CITY OF TACOMA
Public Works Engineering

ADDENDUM NO. 01

Request for Bids Specification No. PW20-0015F
Revitalizing Tacoma's Brewery District

Revitalizing Tacoma's Brewery District

SHEET NO. PV-01 OF PV-03

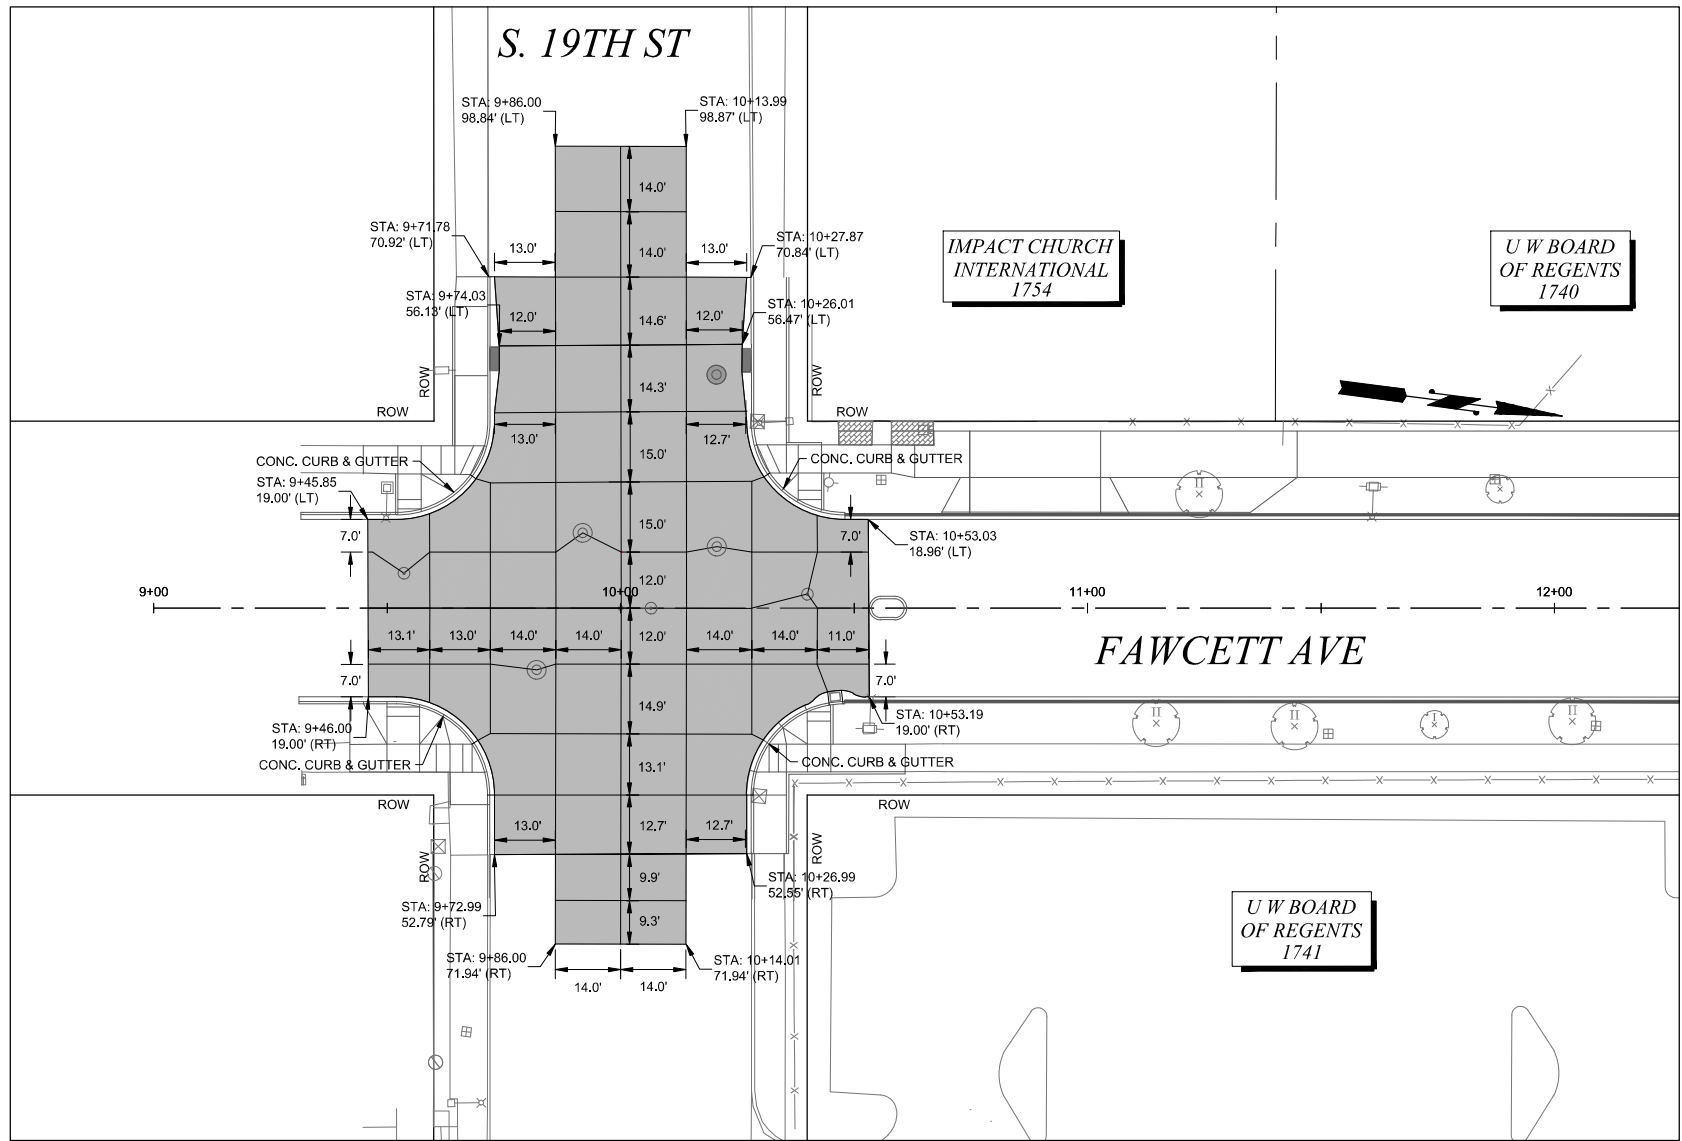
- Delete plan sheet SQ-1 "Summary of Quantities".
- Replace plan sheet PV-01, as attached.
- Replace plan sheet C1, as attached.
- Replace plan sheet D1, as attached.
- Add new plan sheet JT1 "Pavement Jointing Plan", as attached.
